**Re : Planning Application Reference 2023/3017/P
50 Maresfield Gardens, London, NW3 5RX**

Therefore owing to the damage that has resulted to our house from the 2001 basement excavation we have taken technical advice in relation to the latest documents and write to strongly object to the proposals on the following technical grounds. Please could the following comments be passed on to the Council's consultant structural advisors, Campbell Reith Hill LLP to be taken into account when they carry out an audit of the revised Basement Impact Assessment that has been submitted by the applicants.

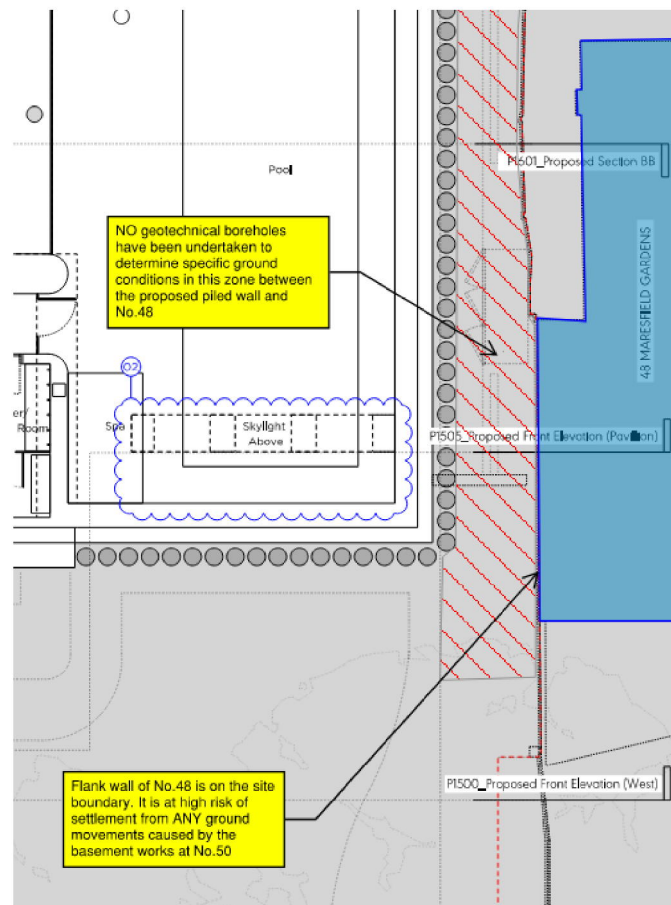
WY drawing No J5106-S-SK-0031 Construction sequence (1 of 4); Note 6. Comments: "Develop a de-watering plan (eg: sump pumps) to pump out water entering basement excavation. Groundwater ingress will be minimised by proposed contiguous piled wall" This is not correct. The proposed wall would comprise 300mm diameter piles at 425mm spacing, leaving 125mm gaps between the piles. Water present in the lenses of sand which were identified in the Geotechnical investigation would be released into the excavation through the gaps in the piles.

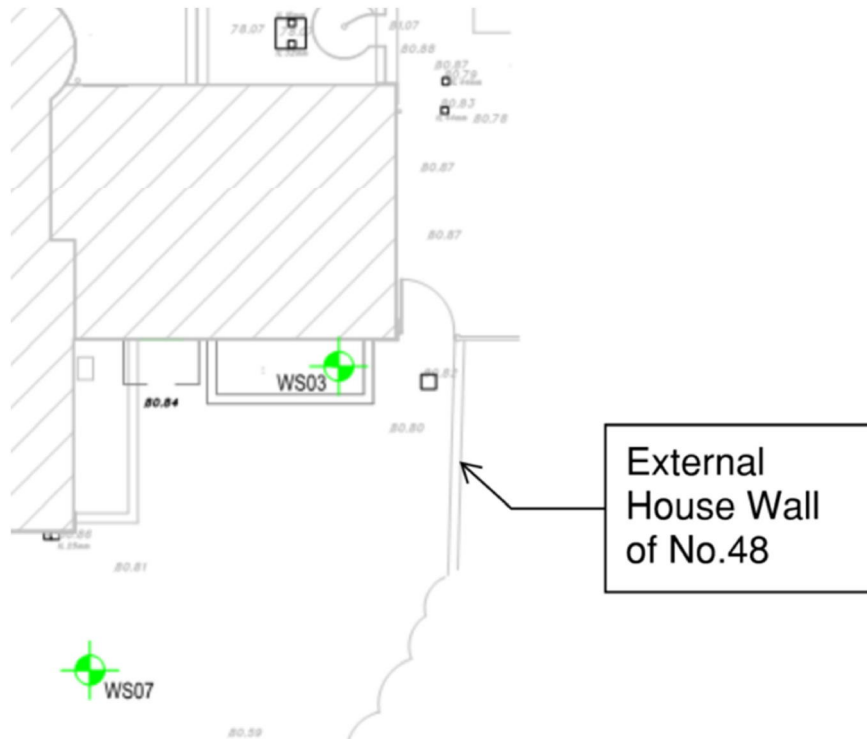
No investigation has been undertaken to determine the ground conditions along this boundary – the closest is WS03, so the strip of ground between the existing Listed Building at NO. 48 and the proposed basement only one metre away has not been investigated, so no site-specific ground conditions for this side of the basement can have been accurately modelled in the ground movement analysis. Furthermore, no trial pits are recorded to have been undertaken on the flank wall of No.48, which sits at only one metre away from the contiguous piled wall. The depth of this foundation and the ground conditions on which it bears are therefore likely to have been inaccurately modelled in the assessment and its implications of the basement construction upon the house at no.48 cannot be relied upon.

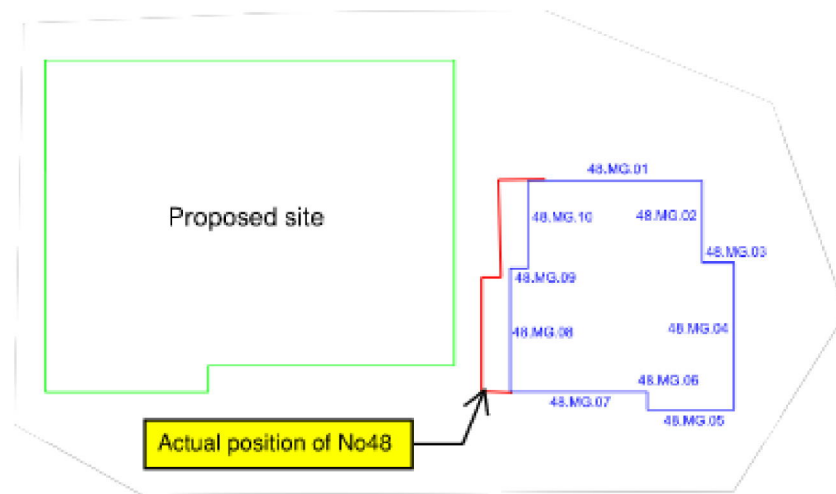
1. The plane level where horizontal and vertical movements are calculated is at +81m AOD, which is the ground level of the development site. However, No. 48 ground level is at about +79m AOD, so the assessment of strains and category of damage is not based on the correct ground movements.
2. The assessment of likely damage category should take account of the existing condition of the house at No. 48, including deformations owing to previous settlements. This has not been done in the BIA.
3. The relative position on plan of No.48 relative to the basement excavation in 4.2 of the BIA is shown about twice as far distant than it actually is. This is incorrect and would underestimate the potential damage to No.48. See figure below.
